Approved Section 4.55 (.....2.....) Modification Application

In respect to.....SSD 7484.....

SANDSTONE PRECINCT
23-39 BRIDGE STREET
SYDNEY, NSW, 2000

DEMOLITION ELEVATIONS LANDS BUILDING - SOUTH AND EDUCATION BUILDING - SOUTH

01 EDUCATION BUILDING - PROPOSED SECTION LOOKING EAST
1:200

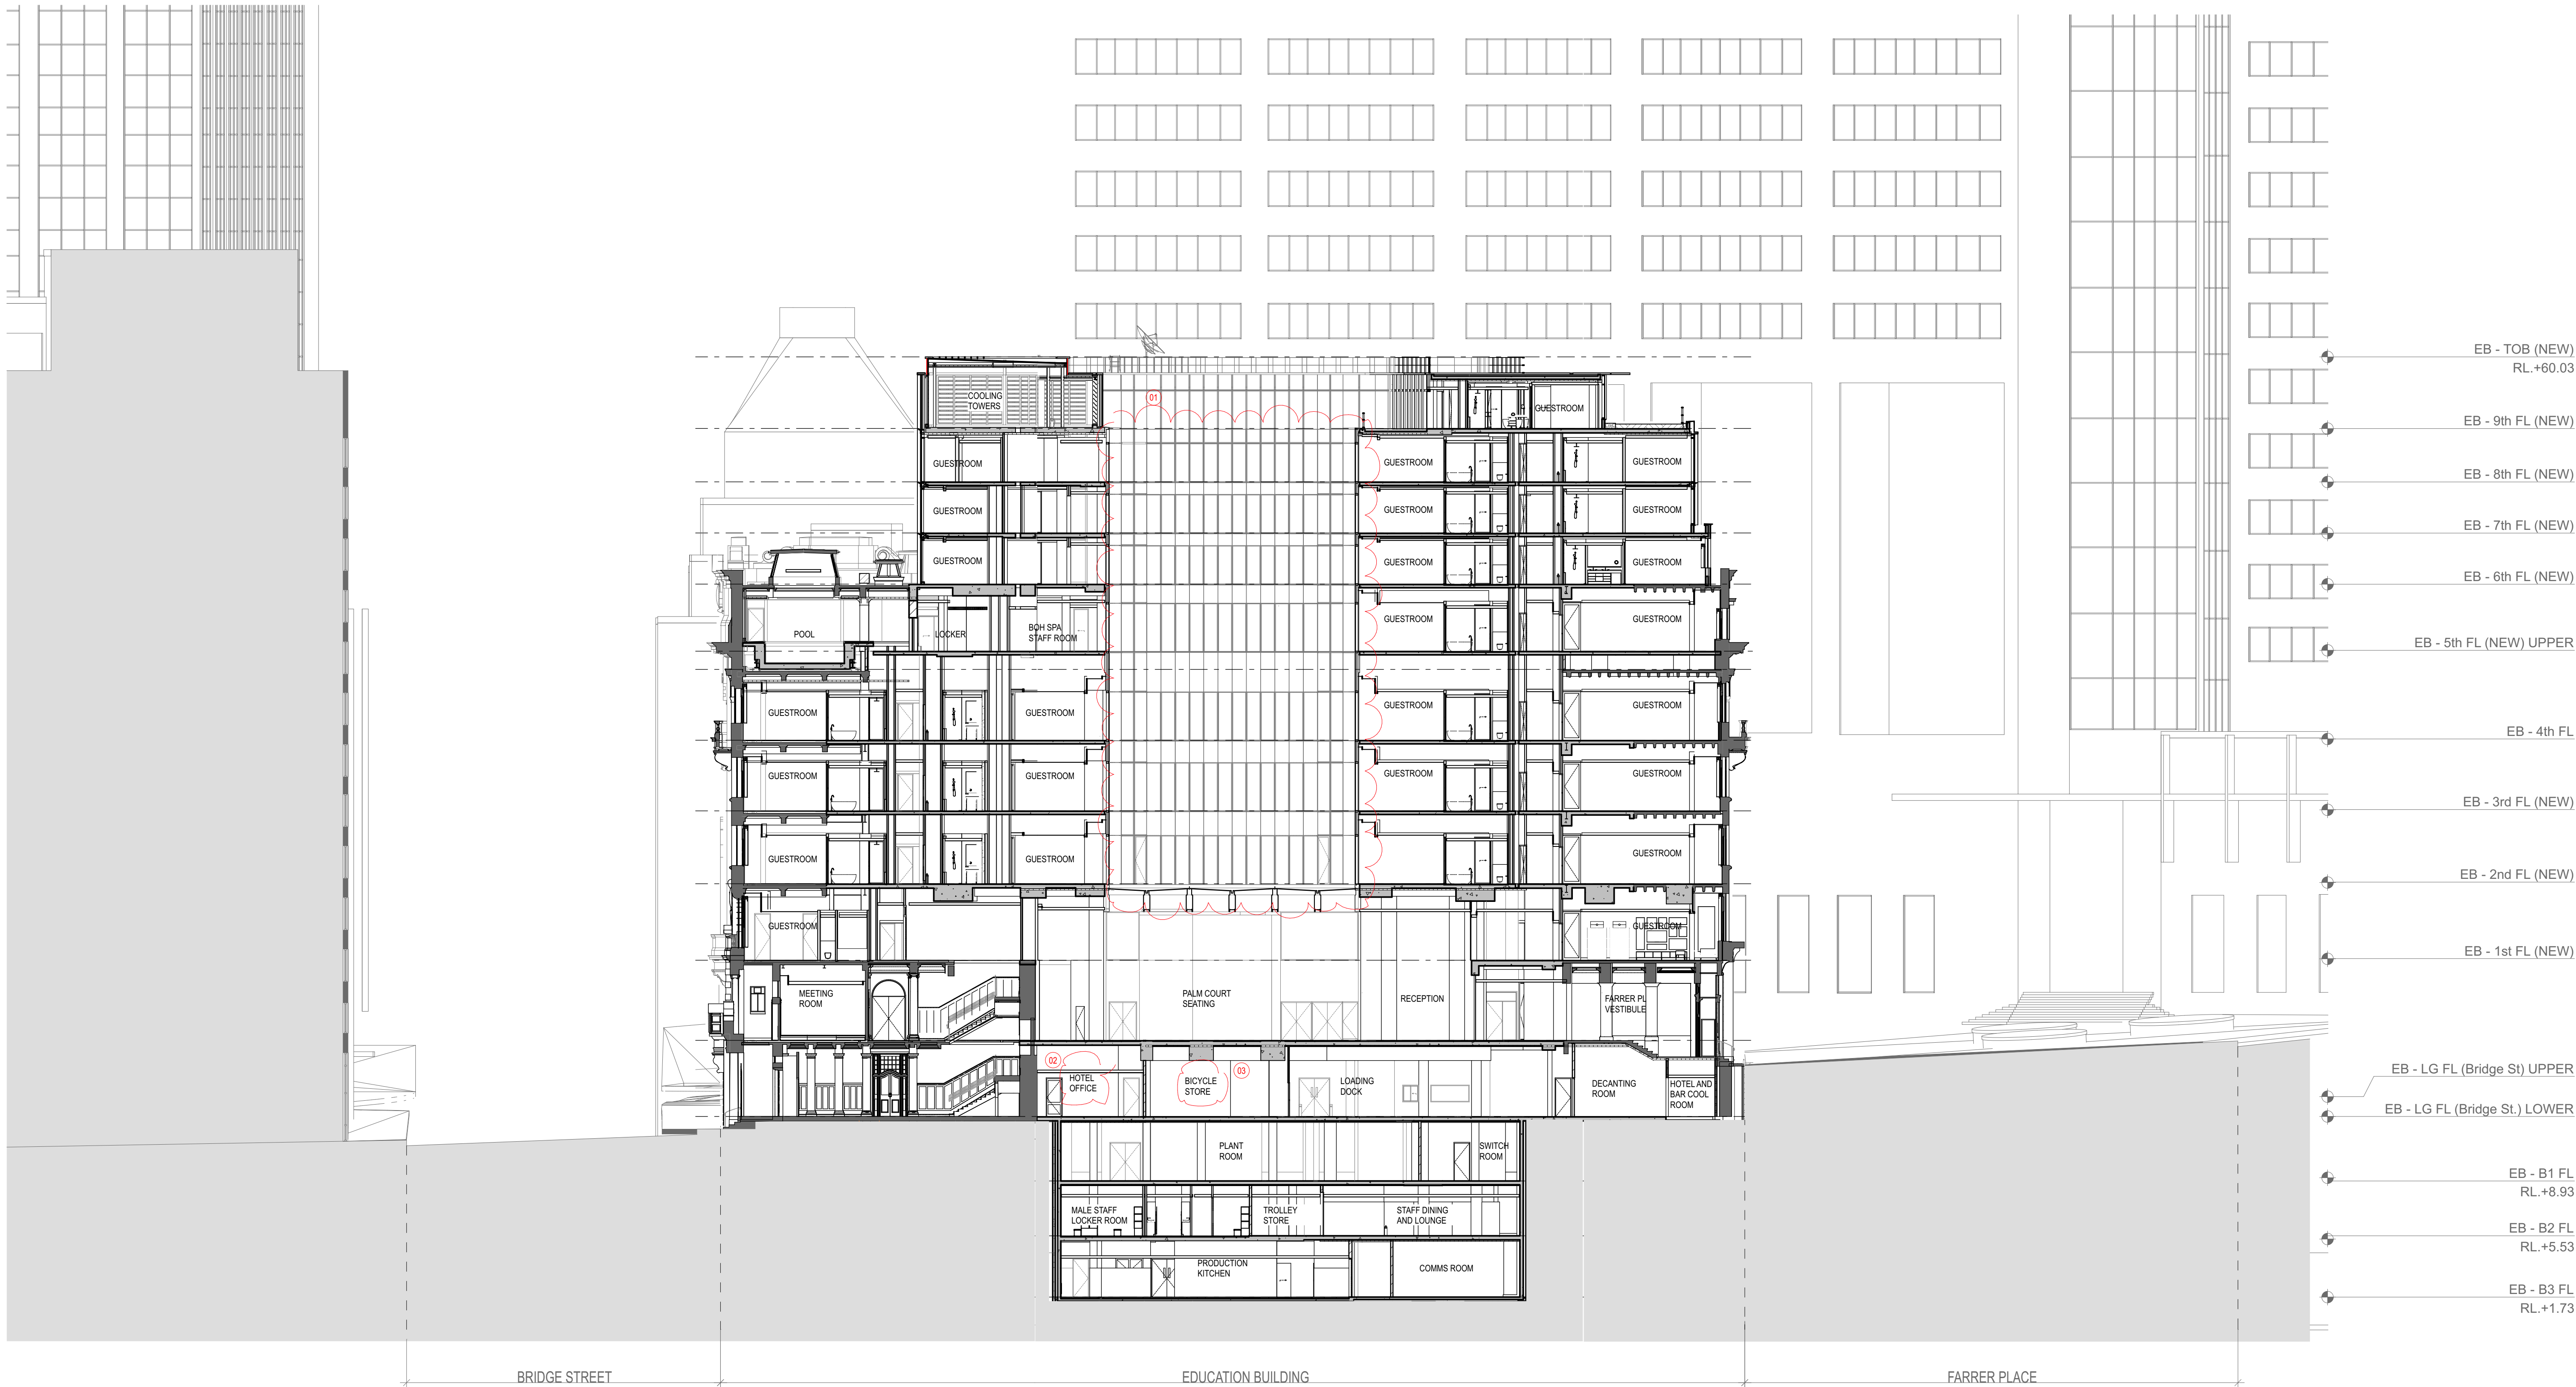
- 01 ADDED CURVE FACADE AWNING
- 02 REPLACED HOME KITCHEN TO BOH HOTEL OFFICE
- 03 ADDED BICYCLE STORAGE
